## Product Update: Display Audio Clock Off by 1 Hour

Supersedes 19-050, dated August 28, 2019, to revise the information highlighted in **yellow**.

Year	Model	Trim	VIN Range
2019-20	RDX	ALL	Check the iN VIN status for eligibility.

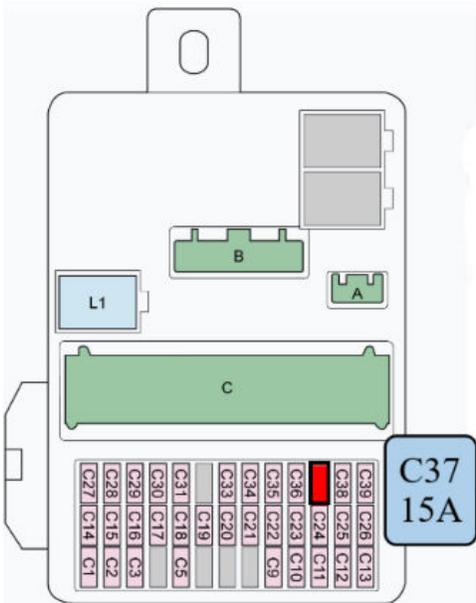
- If **D.1.1.4** or higher is displayed, go to step 6.
  - If **D.1.1.4** or higher is not displayed, contact Tech Line.
6. **Turn the vehicle OFF and** pull the 15 amp B+ radio fuse from the under-dash fuse box for **10 minutes** to clear the data from the audio unit.

If this step is skipped or not correctly done, the client will still experience the issue.
